PLANT NAME: Duane Arnold Plant

Transmitted herewith, in accordance with the requirements of 10CFR50.59 and 50.90, is an application for amendment of DPR-49 to incorporate proposed changes in Technical Specifications (Appendix A to License) for the Duane Arnold Energy Center (DAEC), described in the enclosure hereto.

PROPOSED CHANGE RTS-66A TO DAEC TECHNICAL SPECIFICATIONS

II. Proposed Changes in Technical Specifications

Figure 3.6-1 Change in Charpy V Transition Temperature  
Versus Neutron Exposure

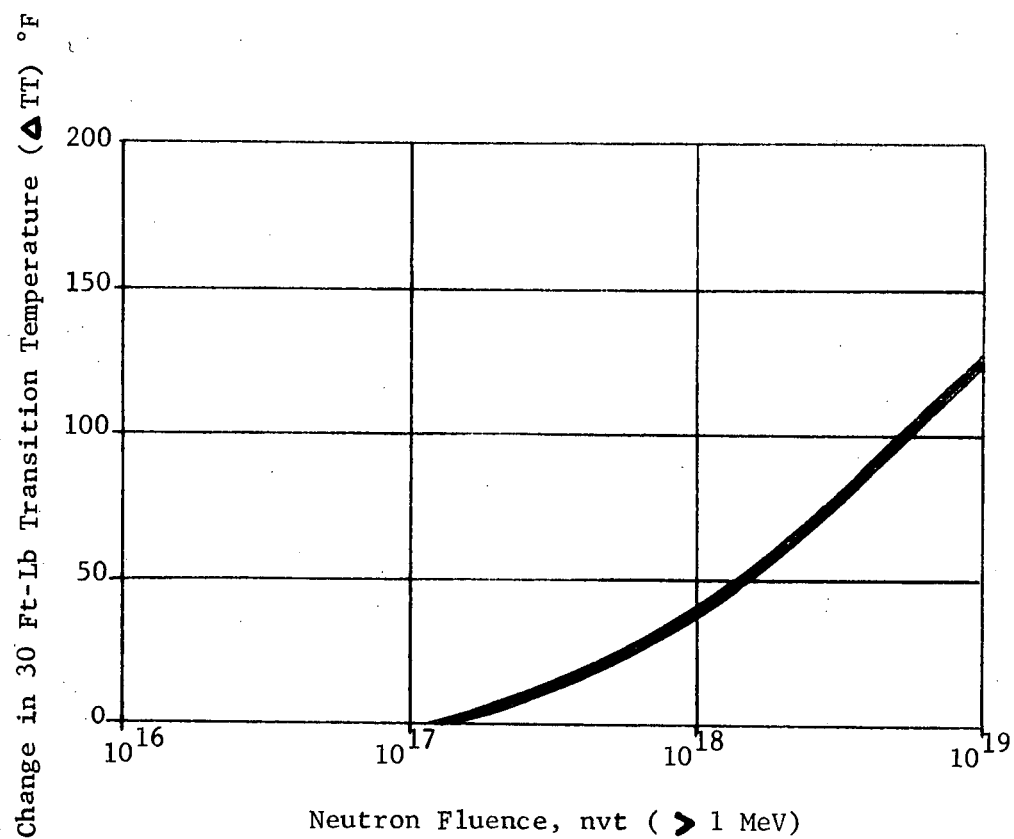
Delete the present Specification 3.6.A and 4.6.A (Limiting Conditions for Operations, Surveillance Requirements and Bases for Thermal and Pressurization Limitations) including Table 3.6-1 and Figure 3.6-1.

Replace with the attached Specification 3.6.A and 4.6.A, including Figures 3.6-1, 3.6-2A, 3.6-2B and 3.6-2C.

General Electric recommendations for making this periodic adjustment include the application of the shift curve, Figure 2, from NEDO-10115 (Figure 3.6-1 of the proposed Technical Specifications), Upper Limit for 550°F GE BWR Operating Experience. Until the estimated neutron fluence at the 1/4 thickness points discussed above reaches  $3 \times 10^{17}$ , there should be no need to make any adjustments to the beltline operating limit curves.

A relationship between neutron fluence and change in Charpy V, 30 foot pound transition temperature has been developed for SA302B/SA533 steel based on at least 35 experimental data points as shown in Figure 3.6-1. In turn, this change in transition temperature can be related to a change in the temperature ordinate shown in Figure G 2110-1 in Appendix G of Section III of the Boiler Code.

2. The reactor vessel shell temperatures during inservice hydrostatic or leak testing shall be at or above the highest of the temperatures shown on the curves of Figure 3.6.2A where the RPV shell beltline region curves are increased by the expected shift in  $RT_{NDT}$  from Figure 3.6-1.

Samples shall be withdrawn at one-fourth and three-fourths service life in accordance with 10CFR50, Appendix H. Neutron flux wires shall be installed in the reactor vessel adjacent to the reactor vessel wall at the core midplane level. The wires shall be removed and tested during the second refueling outage to experimentally verify the calculated values of neutron fluence at one-fourth of the beltline shell thickness that are used to determine the NDTT shift from Figure 3.6-1.

Figure 3.6-2A Minimum Temperature for Pressure Tests

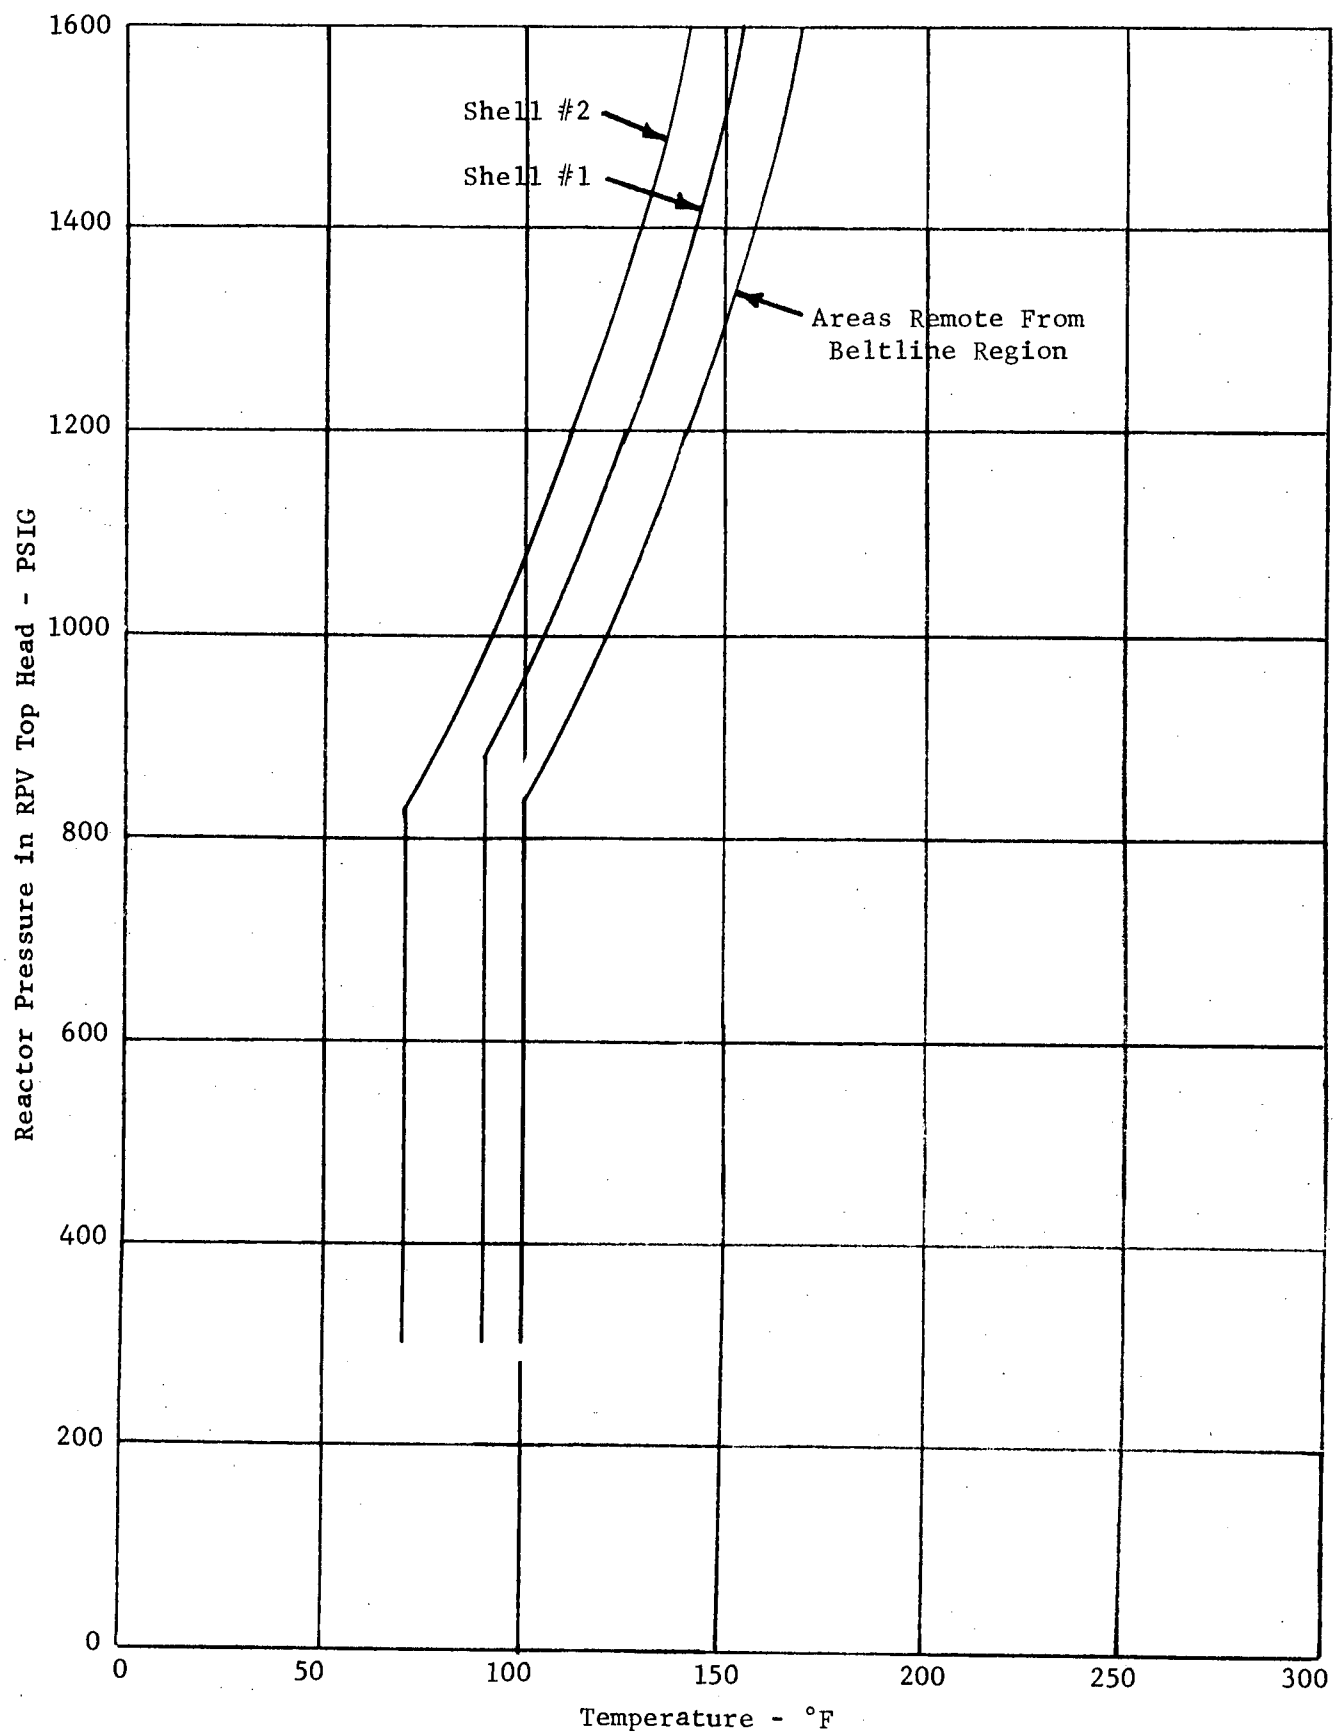
Operating limits on RPV pressure and temperature during normal heatup and cooldown, and during inservice hydrostatic testing, were established using Appendix G to the ASME Boiler and Pressure Vessel Code, Section III, 1971 (Appendix G was first added in the Summer 1972 Addenda) as a guide (see Figures 3.6-2A, B and C of the proposed Technical Specifications). These operating limits will ensure that a large postulated surface flaw, having a depth of one-quarter of the material thickness, can be safely accommodated in regions of the RPV shell remote from discontinuities.

Figure 3.6-2C Minimum Temperature for Criticality

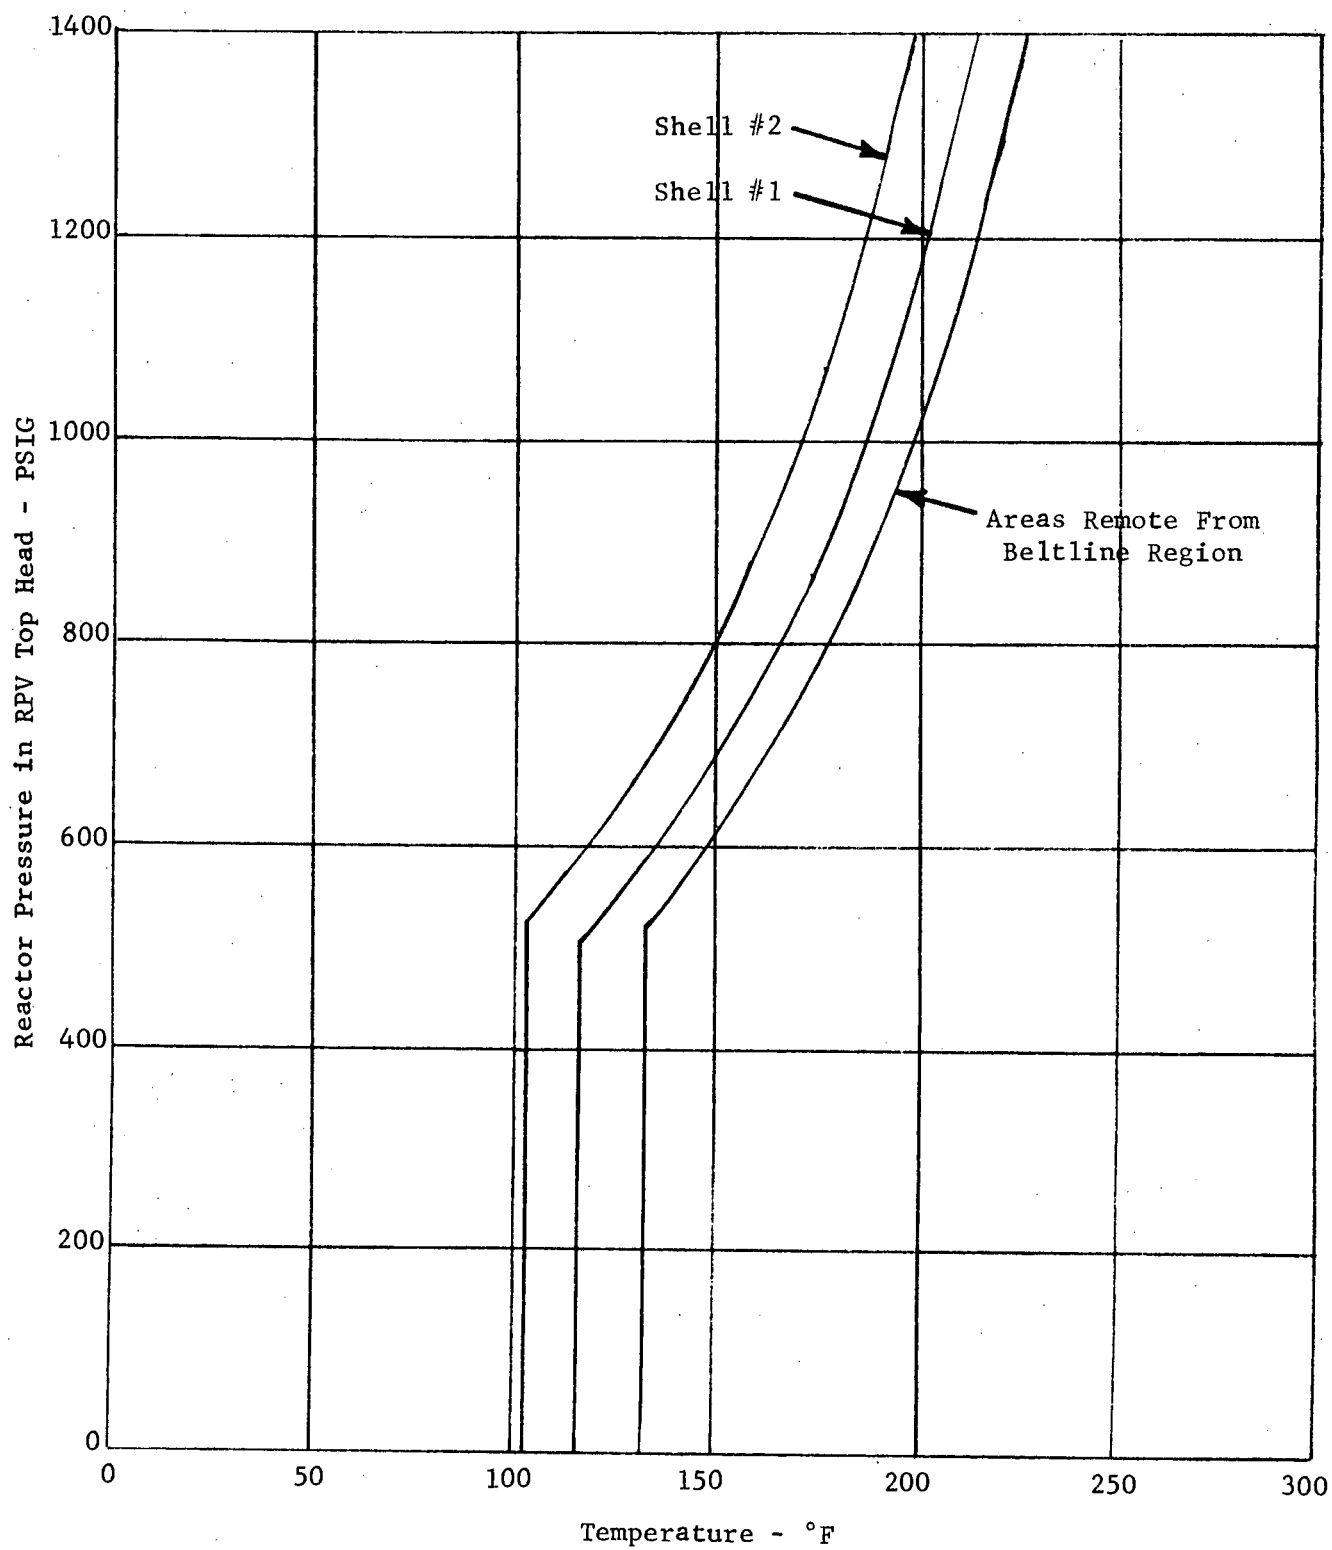
core operation show by vertical lines that no core operation is permitted below the minimum temperature for an 1100 psig ISI hydrostatic test. The enclosed proposed Technical Specifications illustrate the use of the operating limits.

During all operation with a critical core, other than for low level physics tests, the reactor vessel shell and fluid temperatures of 4.6.A.1 shall be at or above the highest of the temperatures of Figure 3.6-2C where the RPV beltline curves are increased by the expected shift in  $RT_{NDT}$  from Figure 3.6-1.
